RE: Electric Owl Holdings, LLC: Petition to Amend the Code of the Village
Site: One South Broadway, Hastings-on-Hudson, New York

On behalf of Electric Owl Holdings, LLC (the "Applicant"), we respectfully submit this letter in response to comments from the Board of Trustees, including Trustee Morgen Fleisig and Trustee Douglass Alligood, regarding the project. This letter further supplements the Application and follows the most recent letters submitted on November 22, November 30, and December 4, 2023 by Cuddy & Feder LLP on behalf of Electric Owl Holdings, LLC (the "Supplemental Letters").

VIEW FROM RIVEREDGE'S POOL

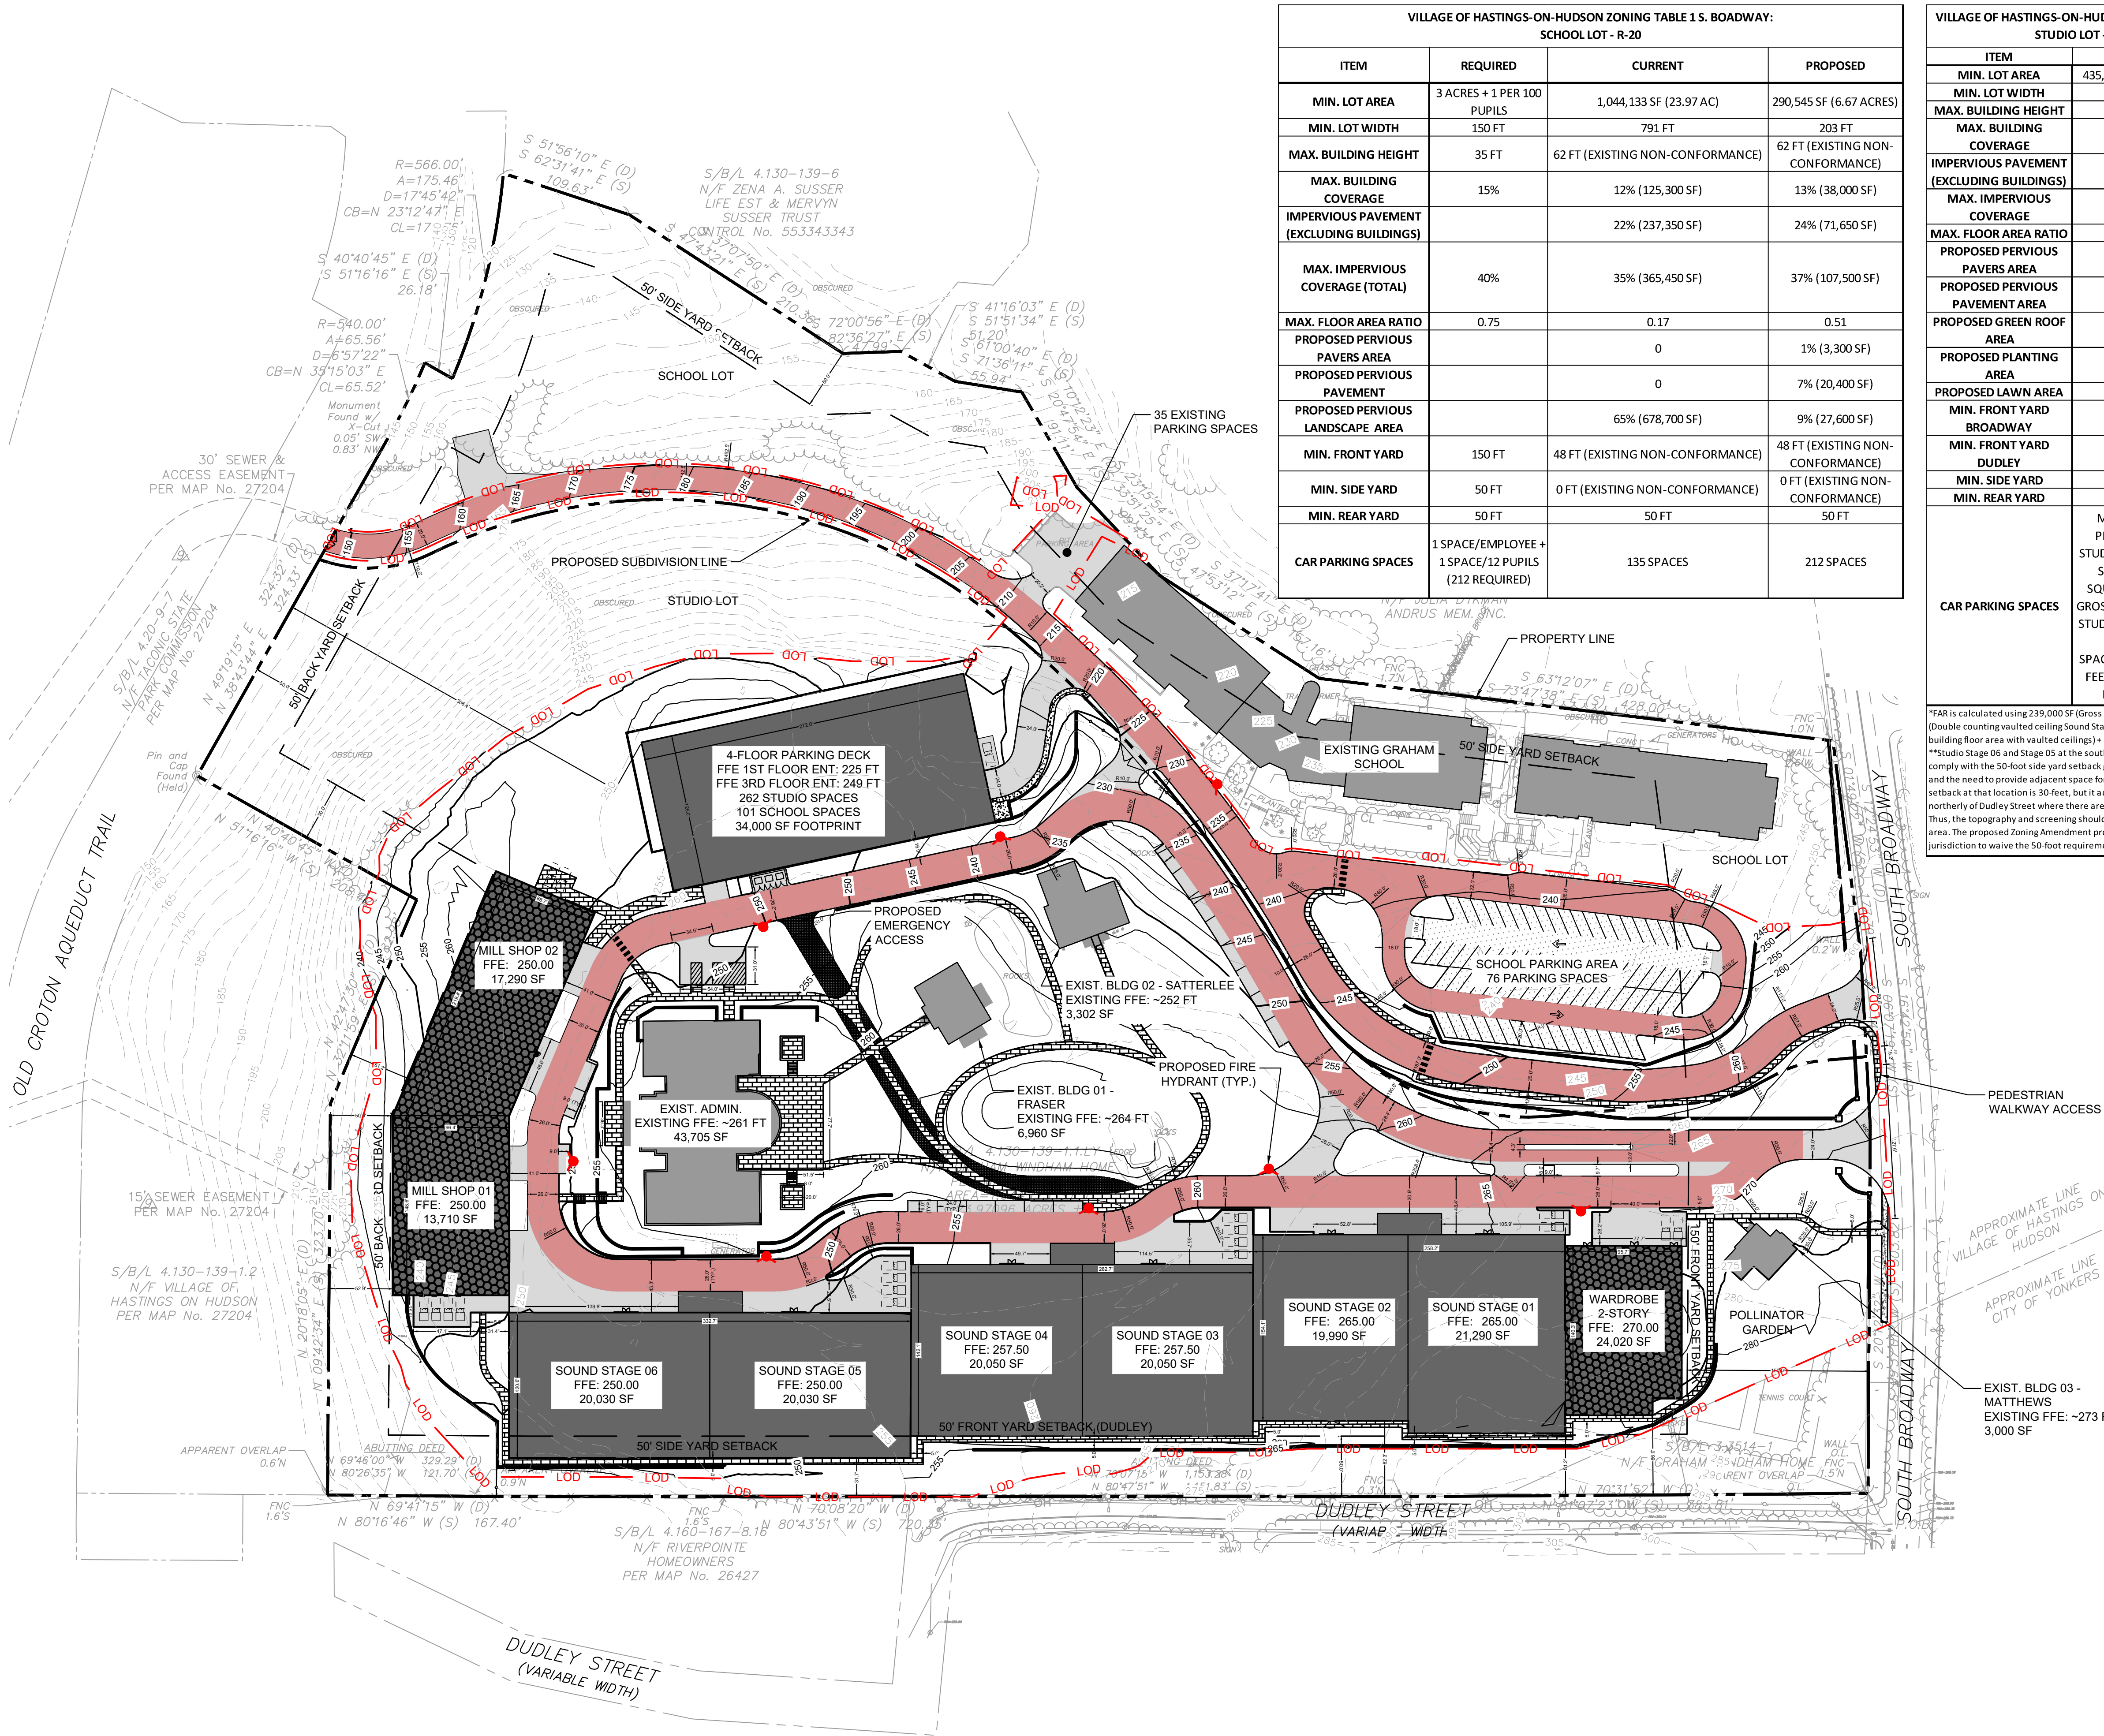
2. **What is the distance between the Site and Riverpointe's swimming pool, as well as its white fence along Dudley Street?**

In addition, we enclose a rendering prepared by Granoff Architects showing the leaf-off view from the Riverpointe swimming pool as it exists today, and also showing the rendered view with the Studio project constructed.
